Service Bulletin No. 452

MODEL J4500	TYPE Field Change Program	SECTION/GROUP 12-Suspension	DATE May 25, 2017
SUBJECT FRONT SWAY BAR			
CONDITIONS

Ref. MCI NHTSA Recall No.:17V-207

Figure 2. Sway bar installation.

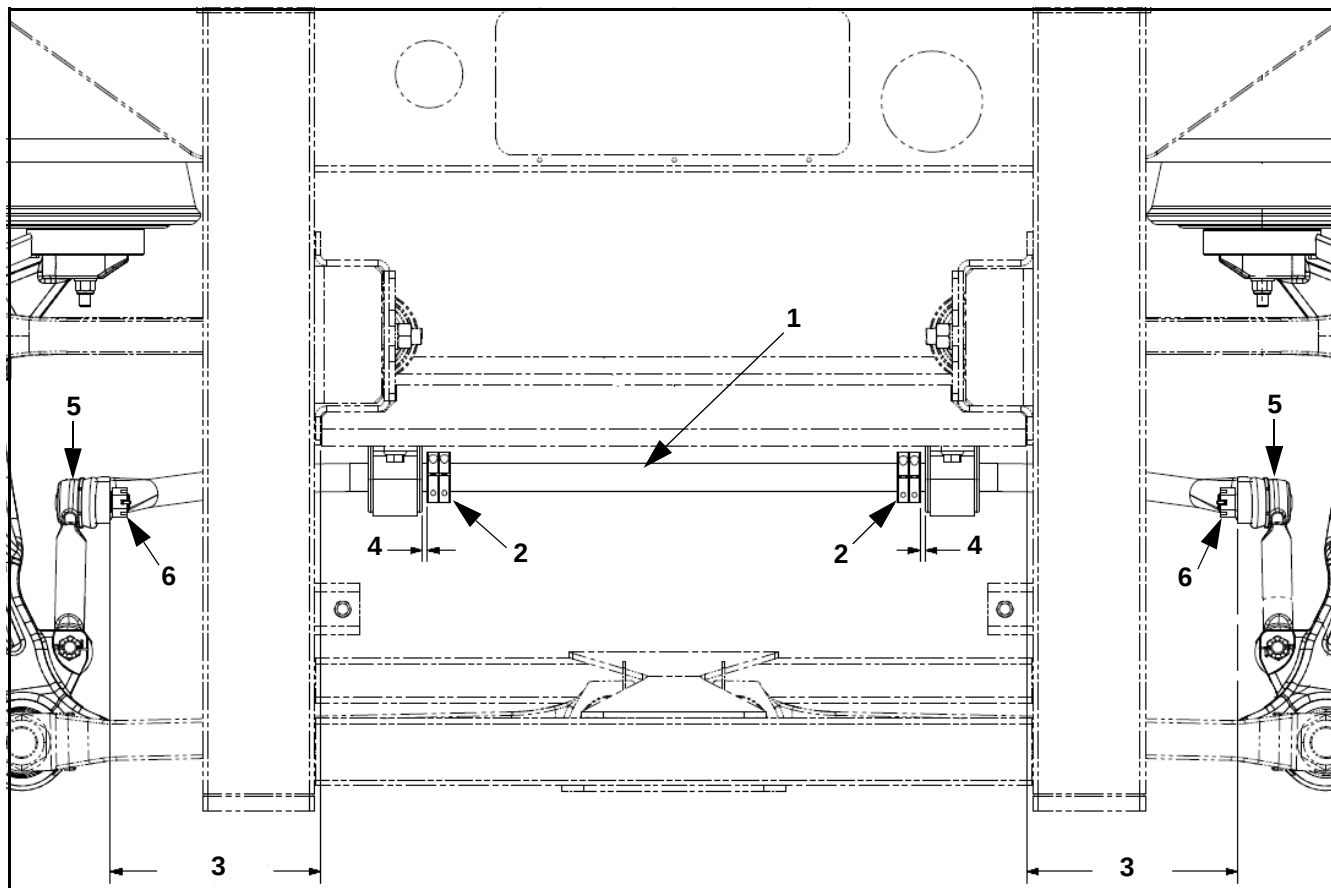
DO NOT remove the existing sway bar links (refer to Figure 2 / Item 5).

Loosen only, DO NOT remove the existing nut from the sway bar link assembly (refer to Figure 2 / Item 6).

3. Remove and discard the existing front axle sway bar.
4. Install the new sway bar and service kit components as shown in Figures 2 and 3.

Item	Figure 2 Description
1	Sway bar
2	Collar. Torque collar allen bolts to 155-175 in-lbs.
3	Distance of 9.37 inches
4	Distance of 0.25 inch
5	Existing swaye bars links. Ensure sway bars links are vertical and spaced equally from uprights.
6	Existing nut
